Access Compliance Report

Public Rights-of-Way

(Curb Ramps)

Intersection ID: 10423	Main Street: ACADEMY_ST	Cross Street: E_SUGAR_CREEK_RD	Location: SE
ADA ID: BF2083DF3B69	Ramp Type: Perp	Initial Pass/Fail: Fail	Overall Compliance: No
Severity Score: 8.75			
Codes/Mitigation Info/Possible Solution		Field Measurements/Component Compliance

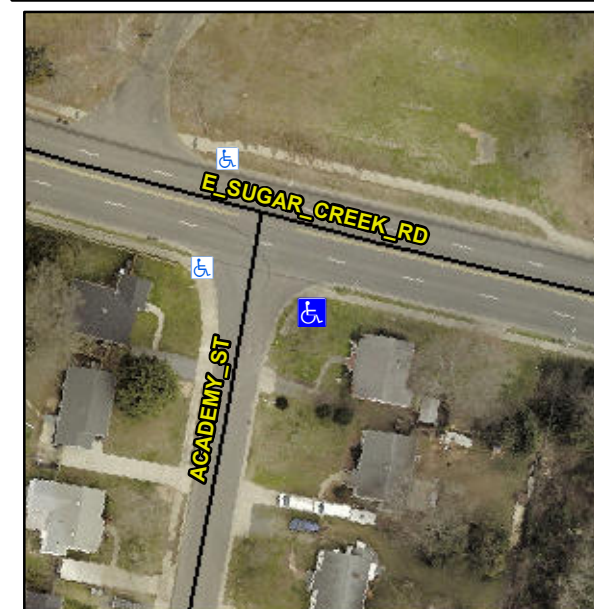
Not Found, R304.5.1

Compliance	Description	Data	Compliance	Description	Data
N/A	Ramp Length (in)	66.0	Yes	Ramp Slope (%)	6.3
No	Ramp Width (in)	36.0	Yes	Ramp XSlope (%)	1.9
N/A	Flare Type LT	N/A	N/A	Flare Type RT	N/A
N/A	Flare Slope LT (%)	N/A	N/A	Flare Slope RT (%)	N/A
N/A	Flare Traversable LT?	N/A	N/A	Flare Traversable RT?	N/A
N/A	Landing Length (in)	N/A	N/A	DWS Provided?	N/A
N/A	Landing Width (in)	N/A	N/A	DWS Contrast?	N/A
N/A	Landing Slope (%)	N/A	N/A	DWS Length (in)	N/A
N/A	Landing X Slope (%)	N/A	N/A	DWS Full Width?	N/A
N/A	Landing Curb? (Y/N)	N/A	N/A	DWS Offset (in)	N/A
N/A	Shared Landing?	N/A			
N/A	Gutter Ponding?	N/A	N/A	Gutter Slope (%)	N/A
N/A	Gutter Lip Ht (in)	N/A	N/A	Gutter X Slope (%)	N/A
N/A	Painted X Walk1?	No	N/A	Painted X Walk2?	N/A
	X Walk 1 Direction	To NW		X Walk 2 Direction	N/A
N/A	X Walk 1 Width (in)	N/A	N/A	X Walk 2 Width (in)	N/A
	X Walk 1 Slope (%)	2.6		X Walk 2 Slope (%)	N/A
	X Walk 1 X Slope (%)	1.1		X Walk 2 X Slope (%)	N/A

N/A	Ramp inside XWalk1?	N/A	N/A	Ramp inside XWalk2?	N/A
	Road Slope (%)	N/A	N/A	Clear Space?	N/A
	Road X Slope (%)	N/A	N/A	Clear Space to XWalk (in)	N/A
N/A	Any Obstructions?	N/A	N/A	Storm Grate/Utility Hazard?	N/A
	Obstruction Type			Storm Grate/Utility Type	
		N/A			N/A
			Yes	Surface Condition? (G/P)	Good

Possible Solutions:

Remove & Replace Entire Ramp.
